DRAFT ECR:

**LIU UPGRADE OF TCDI COLLIMATORS FOR
SPS-TO-LHC TRANSFER LINES (T12/T18)**

TCDI LOCATIONS: T18

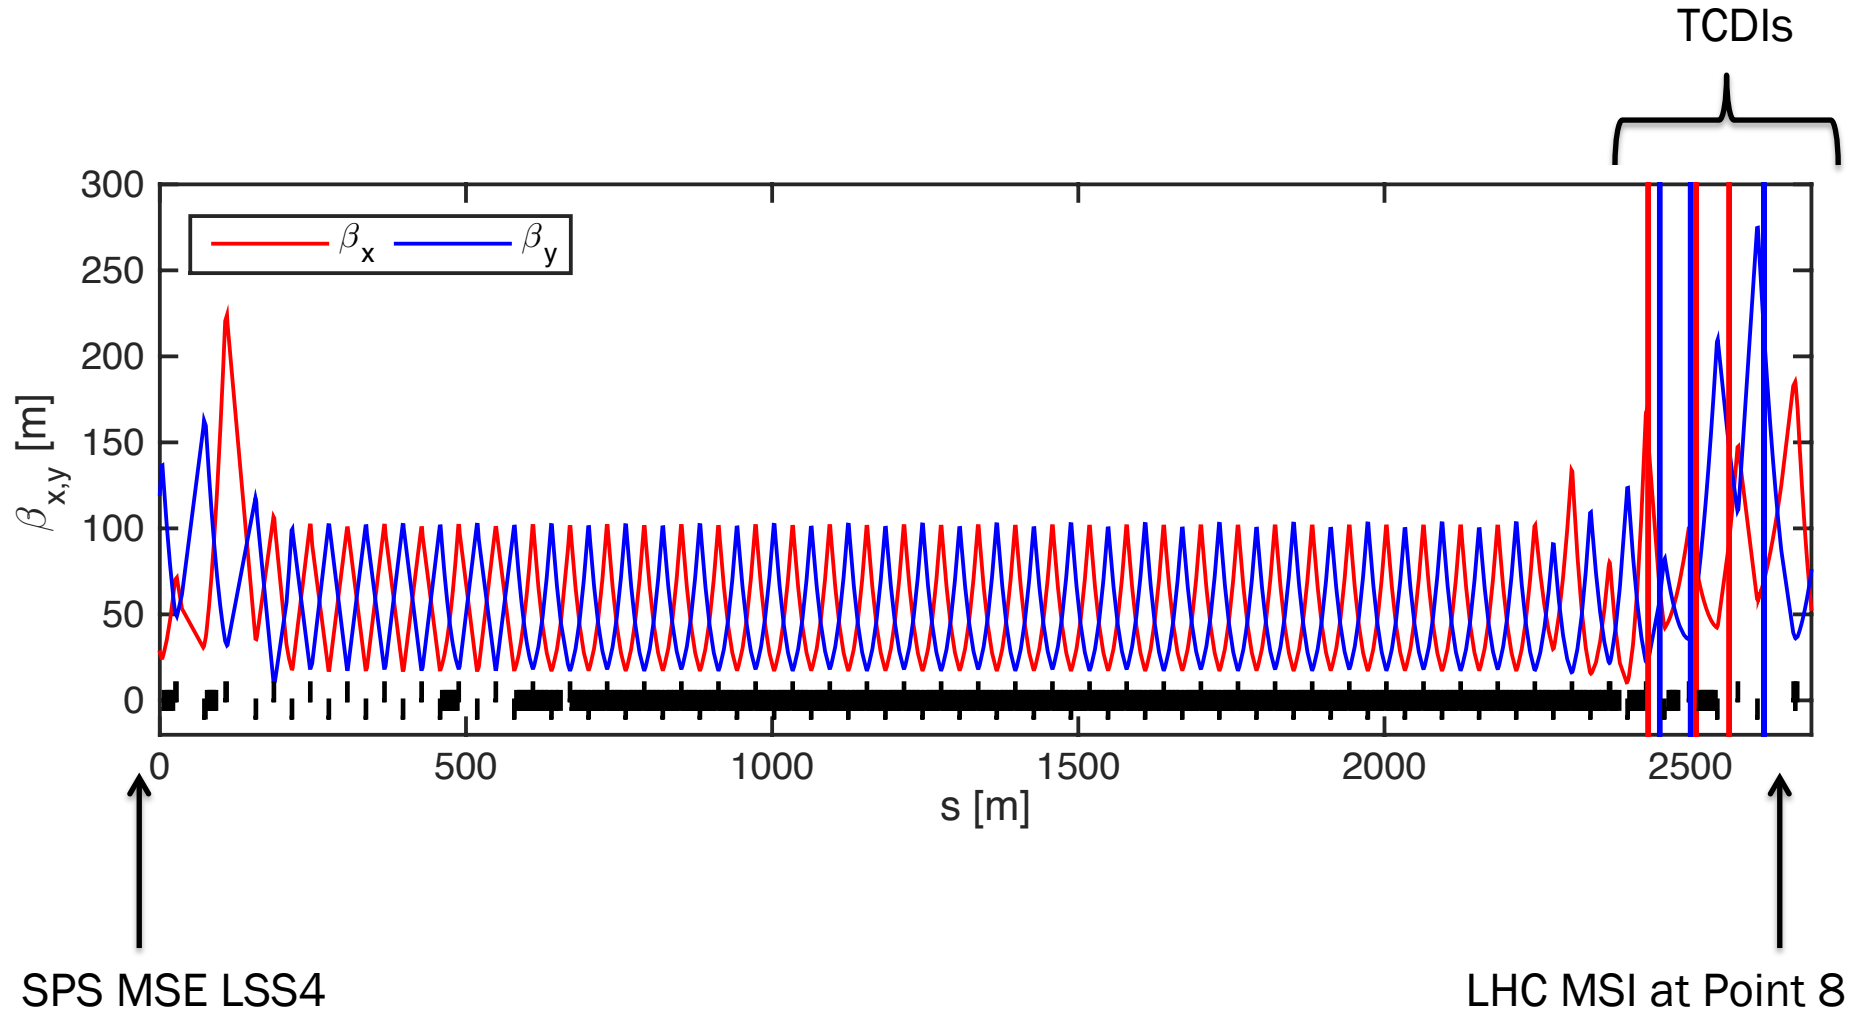
- A total of 12 collimators (3 horizontal and 3 vertical, per transfer line) will be removed and replaced with a longer version (< 2.5 m) based on the same design.
- Most TCDI locations are the same, however, the location of the 3 horizontal collimators in TI8 will change significantly.
- In TI2 there is no change of TCDI position, all TCDIMs stay in the same place.
- In TI8 all 3 TCDIHs change positions, all TCDIMs stay in the same place:

Existing Collimator Name	Existing Position <u>Send</u> [m]	New Collimator Name	New Position <u>Send</u> [m]	Difference in Position [m]
TCDIH.87441	2387.665	TCDIH.87606	2432.032	+44.37
TCDIV.87645	2450.165	TCDIV.87644	2450.625	+0.50
TCDIV.87804	2499.965	TCDIV.87804	2501.125	+1.16
TCDIH.87904	2546.152	TCDIH.87822	2509.930	-36.22
TCDIH.88121	2619.837	TCDIH.87939	2564.460	-55.53
TCDIV.88123	2621.237	TCDIV.88121	2620.897	+0.34

OPTICS: T12

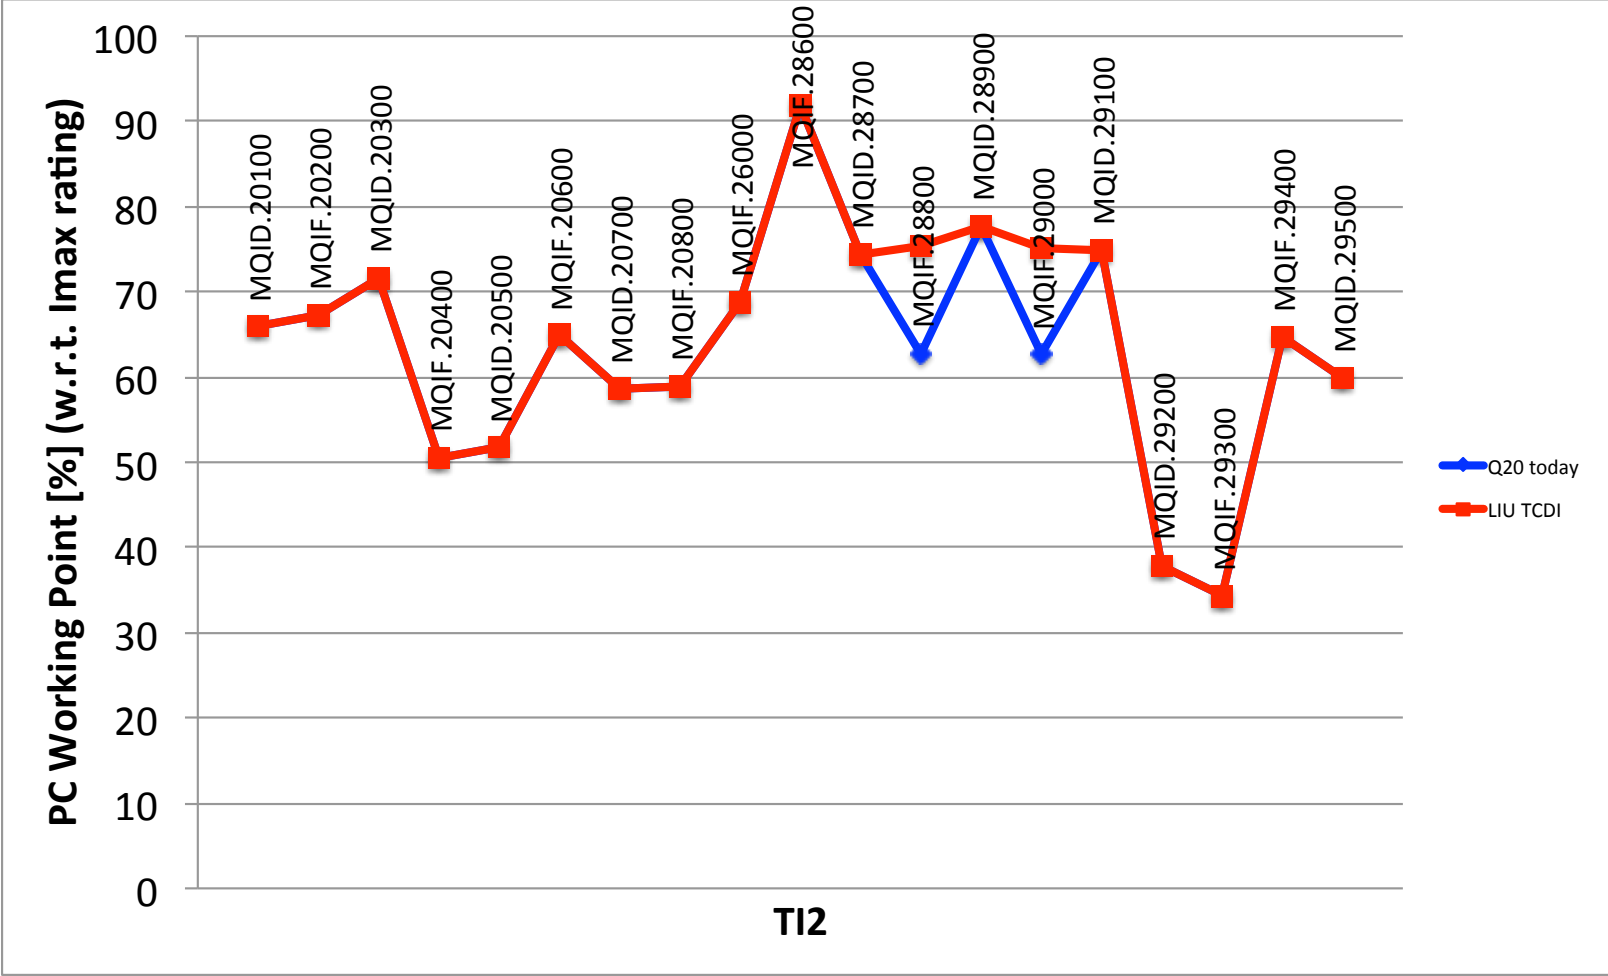
➤ Working point of power converters with 2 COMET power converters swapped in: the maximum current is rated 100 A lower:

OPTICS: T18

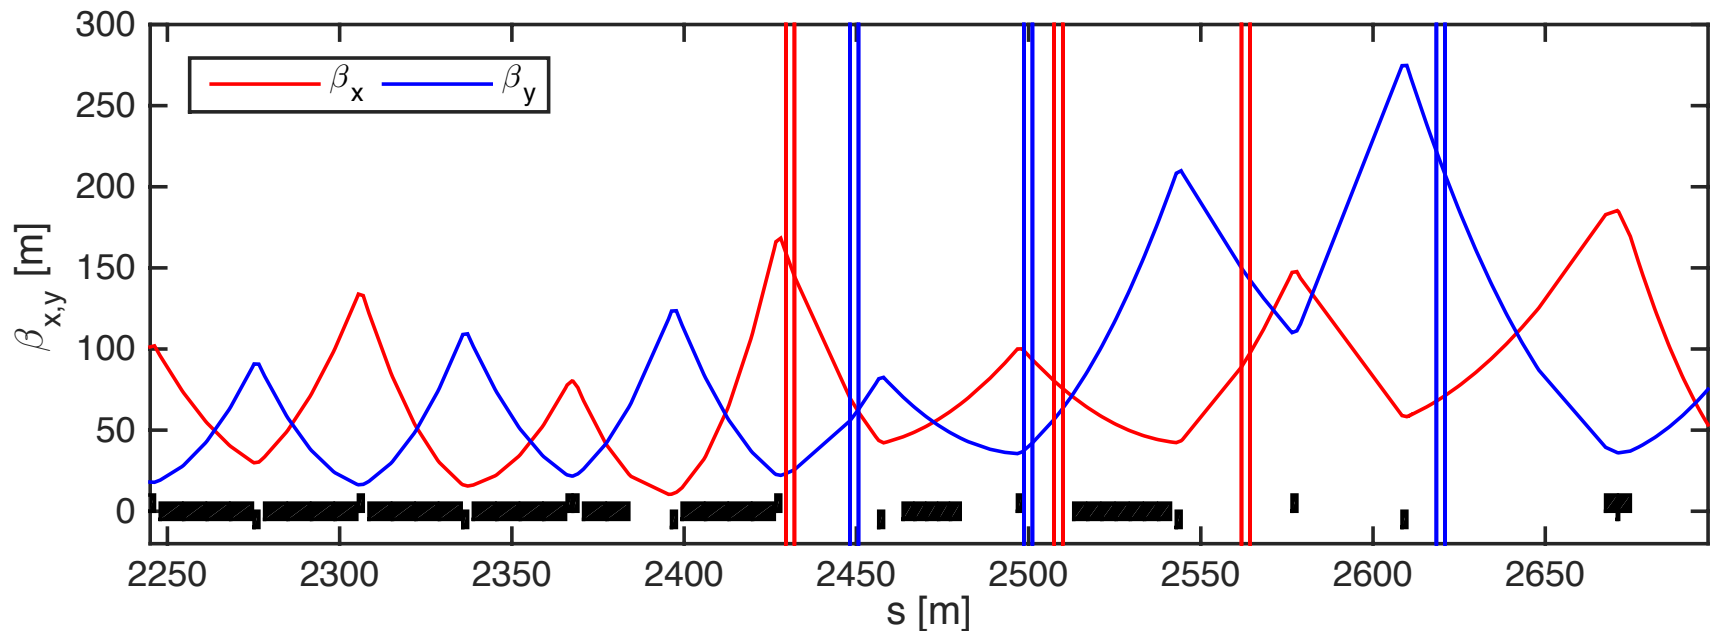
- Optics has to change from the Q20 optics presently used because of the limited space available to place longer TCDIs.
- TCDIMs are unchanged.
- Two additional LEP (RB6) power converters taken from T12 for MQIF.87000 and MQID.87100 in SR8, presently powered in series with circuits RQIF.80400 and RQID.80500.

OPTICS: T18

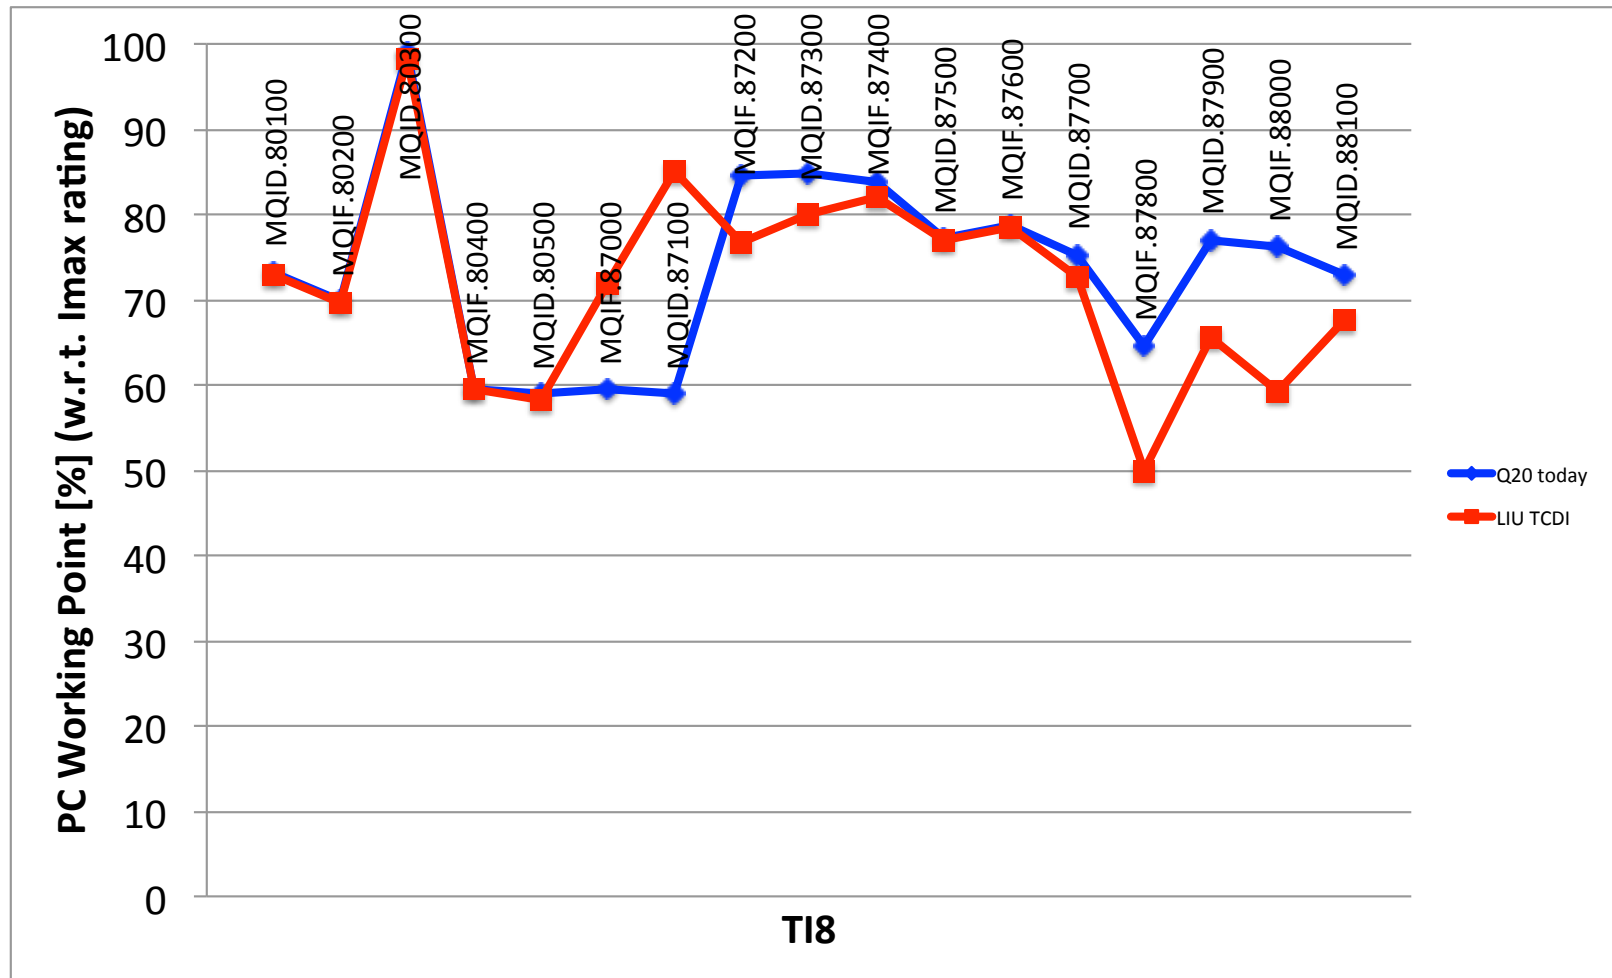
- Working point of power converters with 2 additional converters of the LEP (RB6) type, swapped from T12:

EXAMPLE INTEGRATION DRAWING

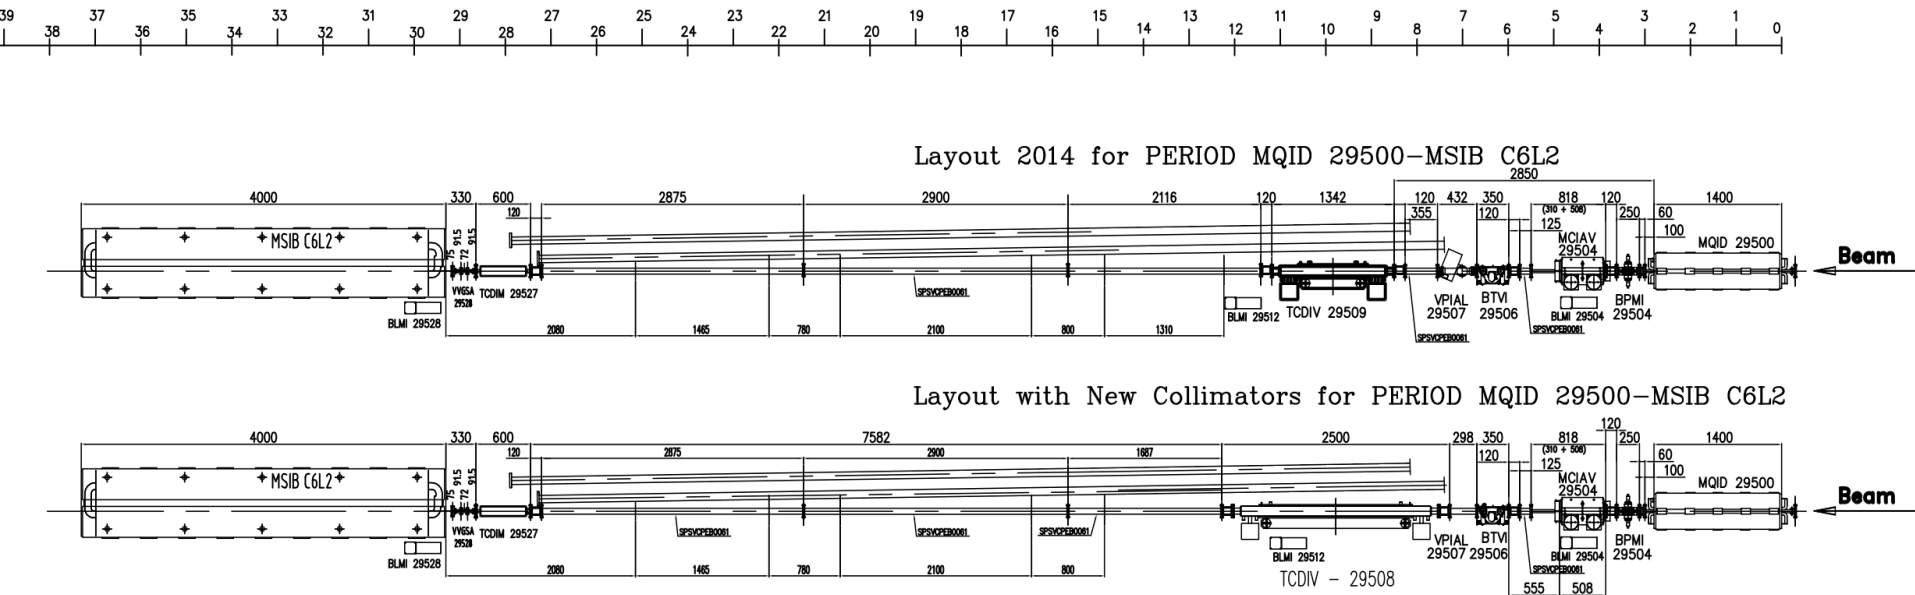
- In most cases, the installation will be a similar procedure as for the original TCDIs.
- Frederic Galleazzi has prepared new drawings based on 2.5 m TCDIs and identified issues where installation is more complicated (TCDIH.87939 to be discussed later)
- As an example, the last TCDIV in TI2 swapped with a new collimator:

IMPACT ON OTHER SYSTEMS

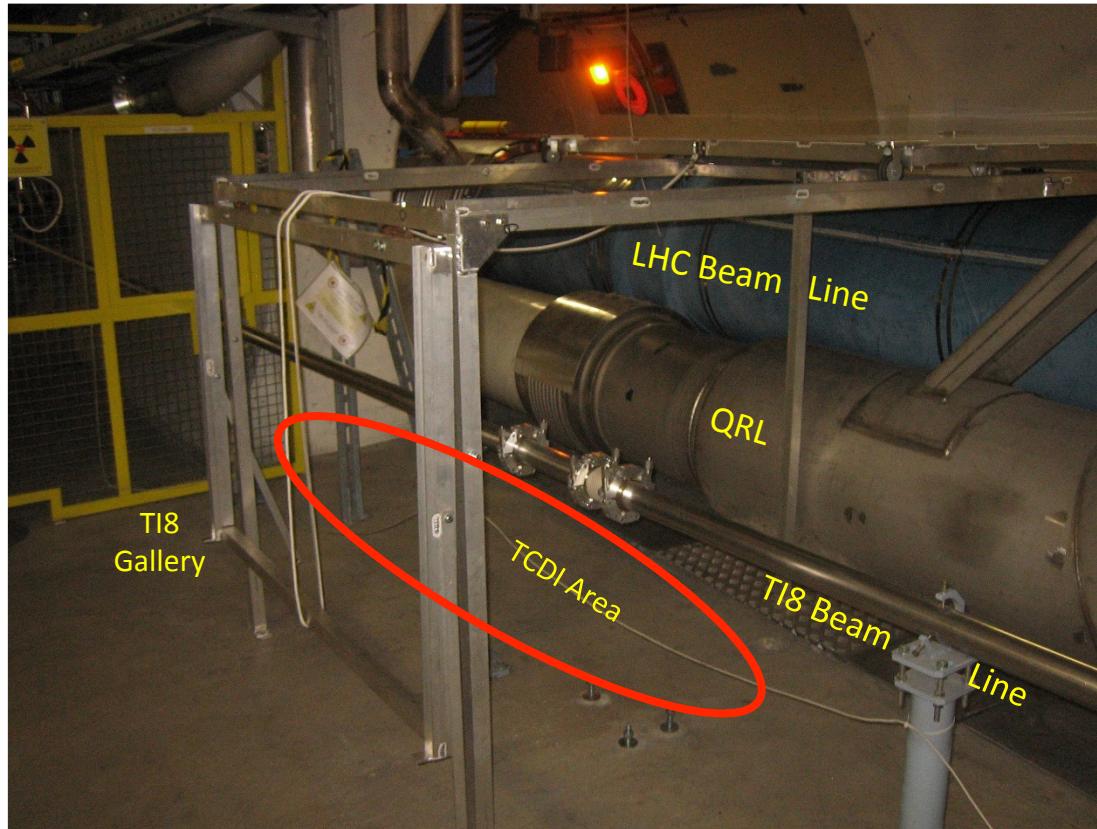
- Passerelle/Plates-Formes for Patrol in Point 8 (LHC-HPMQ-EC-0001) :

- Frederic identified this issue. As I understand it, the passerelle will be dismantled and moved during LS2: an integration study is needed to find it new position.

INSTALLATION TCDIH.87939

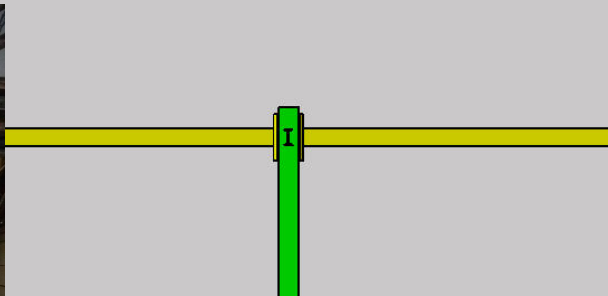
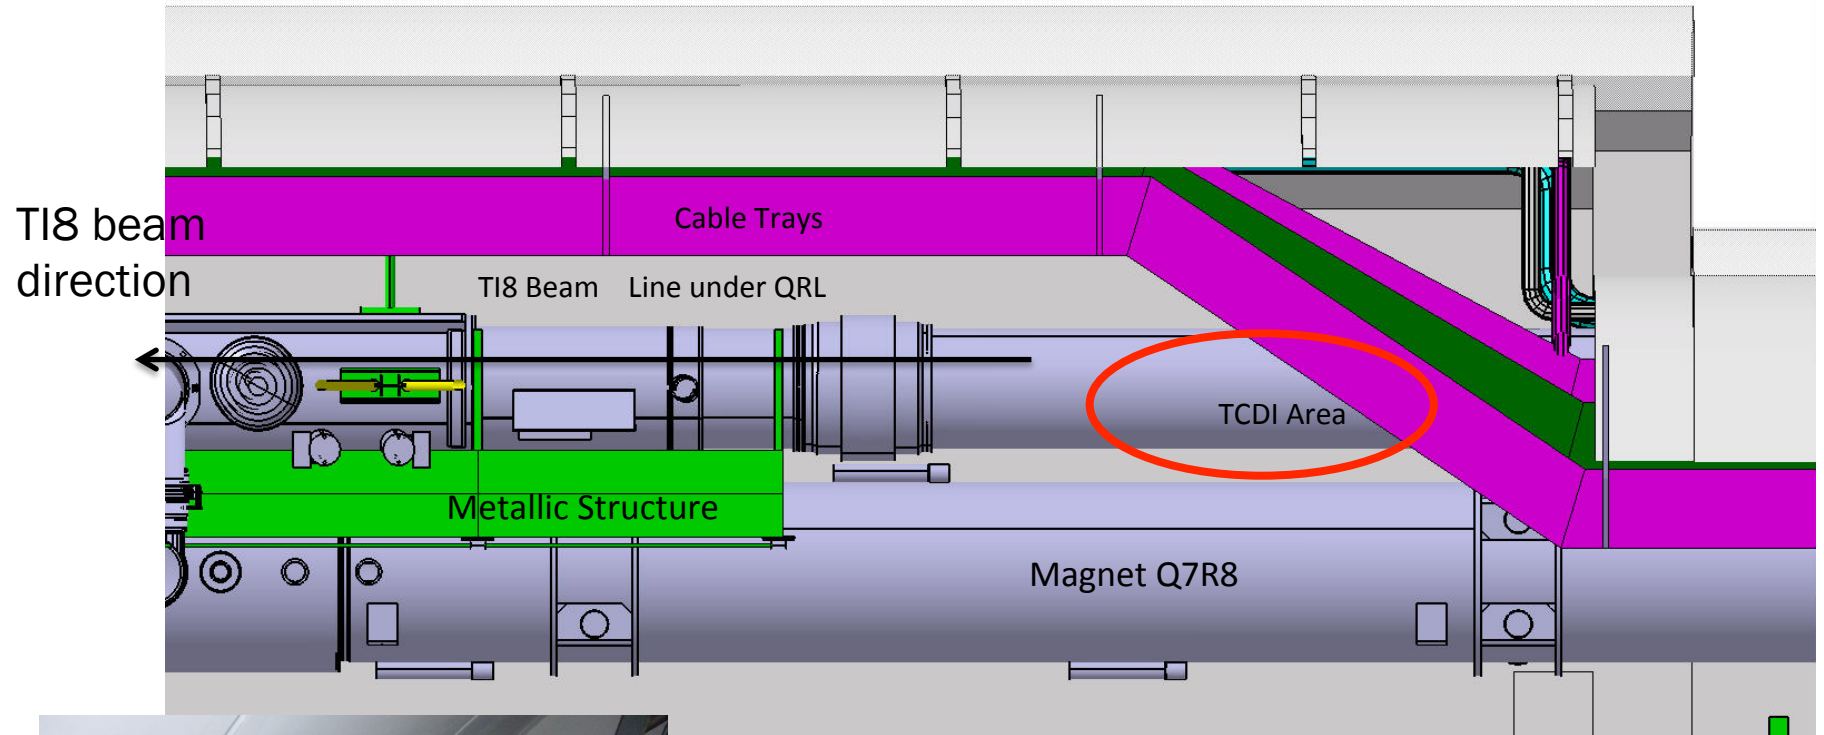
- **Special transport/handling:** the installation of TCDIs close to LHC (where space is restricted) will need special transport and handling, in particular for TCDIH.87939. Frederic Galleazzi has already investigated some options for installation, please see LIU-SPS BL, Pro., TL WG: <https://indico.cern.ch/event/354946/>
- Some special tooling/craning exists but certainly for TCDIH.87939 this should be followed up.
